MODIFICATION INSTRUCTIONS

KODAK MULTILOADER 700/700 PLUS SIDE-BY-SIDE KIT

MODIFICATION No. 2

PURPOSE:

figure 1-1

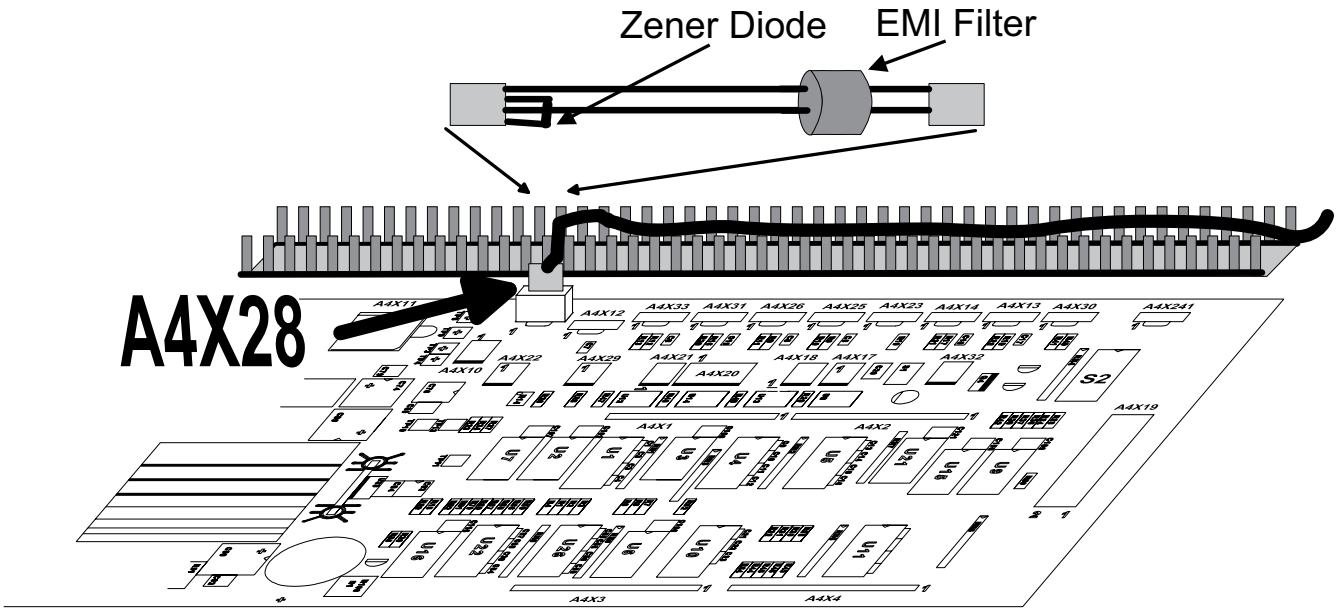
There have been cases where Electrical Static Discharges (ESD) from the Dark Room Feed Tray have passed via the cable to the PCB A4 causing premature failure of the PCB. To further protect the PCB A4 it has been found necessary to install a Zener Diode and an EMI Filter.

4. Disconnect connector A4X28 at the PCB A4 and connect it to the cable delivered with Modification Kit
